NO. SI 62-007

Austro Engine Mandatory Service Bulletin No. MSB-E4-024/1
ATA-Code: 71-00

No. MSB-E4-024/1

Waste gate – Spring loaded circlip

Example: Turbo charger for engine configuration "-A" with new spring loaded circlip

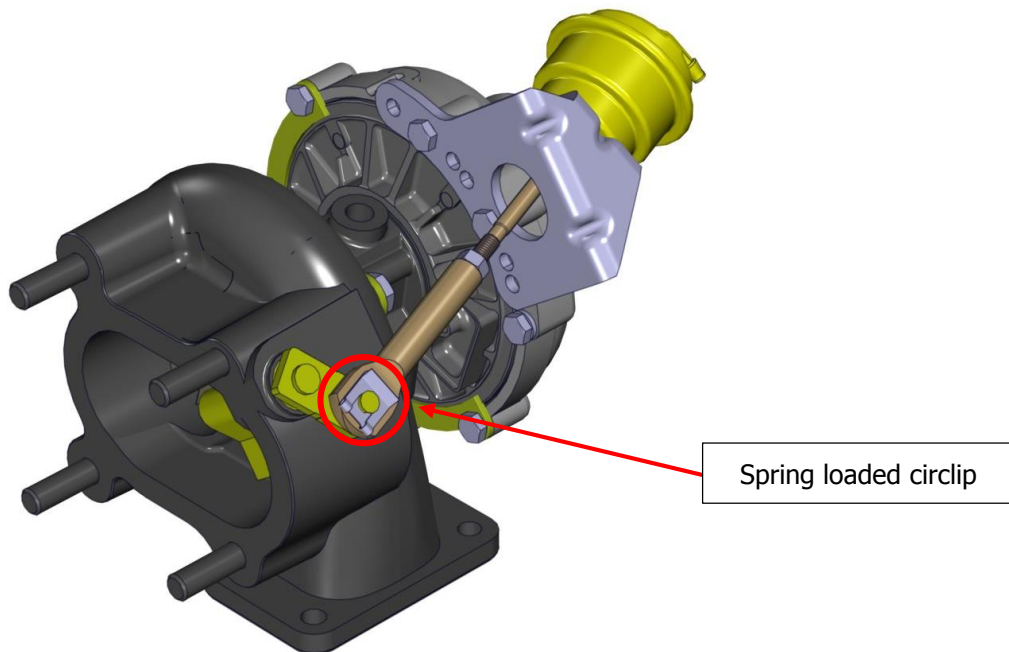
This Service Bulletin describes the replacement of the waste gate circlip, which prevents the waste gate actuator connection rod from disconnecting from the waste gate bolt of the turbo charger. An improved circlip design prevents the incorrect installation of the circlip.

Replace the circlip DIN6799-5 with the spring loaded circlip E4A-41-100-801.
